[BSCBA24-A-01](#): Signature Homes; Appeal of Section R-313.2 of the 2021 International Residential Code and calculation of square footage interpretation

**Meeting:** Building Safety Code Board of Appeals  
**From:** Michael Frank, Building Inspector  
Nicholas Hanson, Building Official  
**Date:** April 24, 2024  
**Subject:** 2843 E. Stone Creek

Signature Homes recently questioned the City’s interpretation of R312.2 and stated the second floor open area should not be counted, as the builder does not count it as square footage. Therefore, our office reached out to ICC for their interpretation, which was in agreement with the City.

**SECOND FLOOR PLAN**

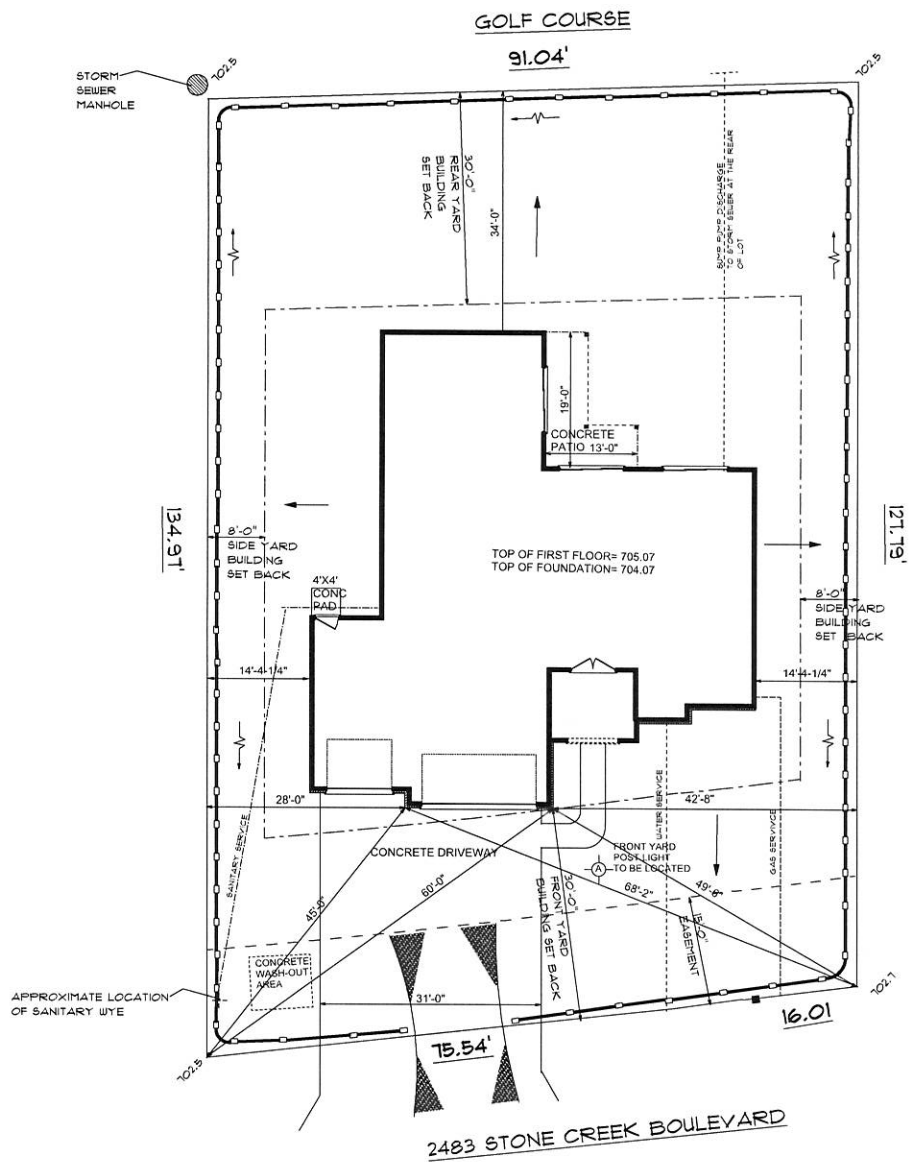
REQUIREMENT OF AN AUTOMATIC RESIDENTIAL FIRE SPRINKLER SYSTEM DUE TO GROSS SQUARE FOOTAGE OF PROPOSED PLANS

THE GROSS SQUARE FOOTAGE OF THE HOME IS 5,729 SQUARE FEET, (UNDER 6,000)

THEREFORE A SPRINKLER SYSTEM SHOULD NOT BE REQUIRED

**SECOND FLOOR PLAN**

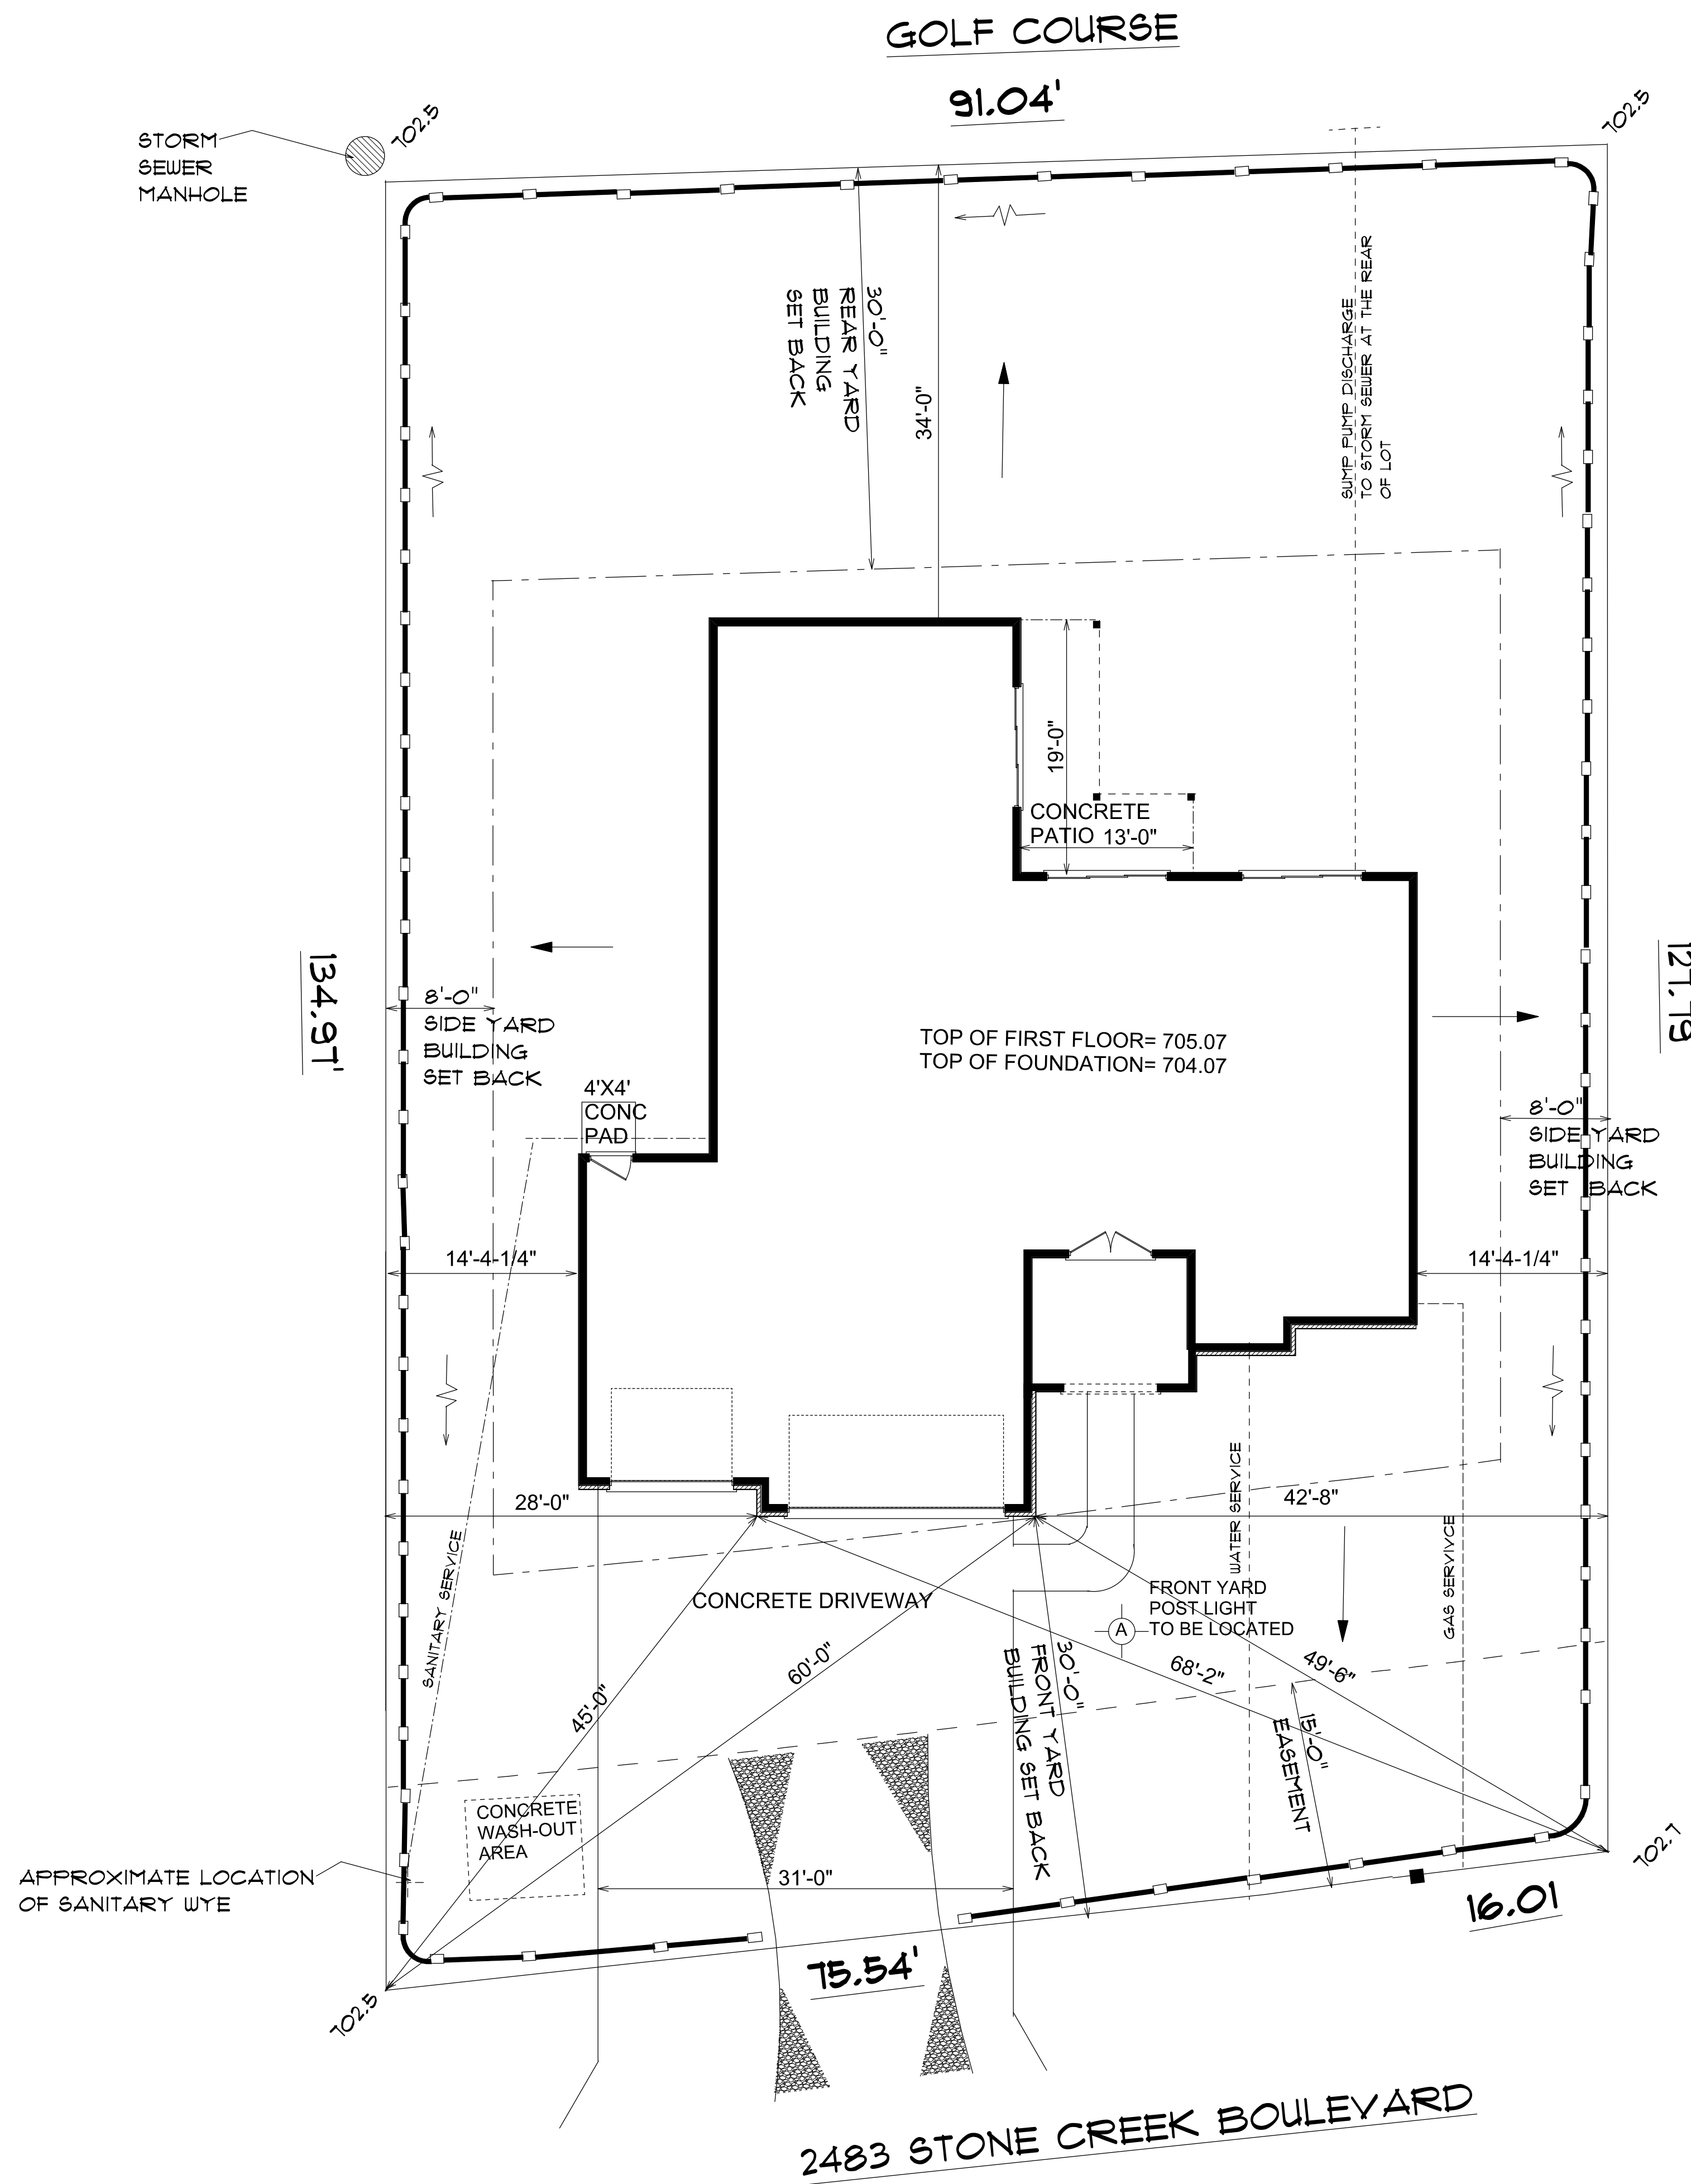
This opinion is in response to your submitted ICC-online staff opinion request of March 26, 2024, and our phone conversation on April 10, 2024. You wish to know if, based on the definition of “Floor Area, Gross” in the 2021 IBC, whether the open space on the second floor, as indicated in your attached drawing, is included in the gross floor area.

Based on the definition, the gross floor area on the second floor would include the area of the floor opening. It should be noted, however, that the definition of "Floor Opening, Gross" is found in the 2021 IBC and not in the 2021 International Residential Code (IRC). To our knowledge, this term is not used in the 2021 IRC since the IRC does not have area limitations for detached one- and two-family dwelling and townhouses.

Should the second floor open space be counted in the gross square footage as defined?

As previously described, the lightweight construction, faster burn rates, toxic gases, and higher temperatures within large open-concept residences often lead to catastrophic loss of both life and property. Therefore, City staff recommends counting the open space as defined by the Code and the proposed residential structure either be redesigned to fall below the 6,000 sq. ft. threshold or require the installation of a fire sprinkler system in compliance with NFPA 13D.
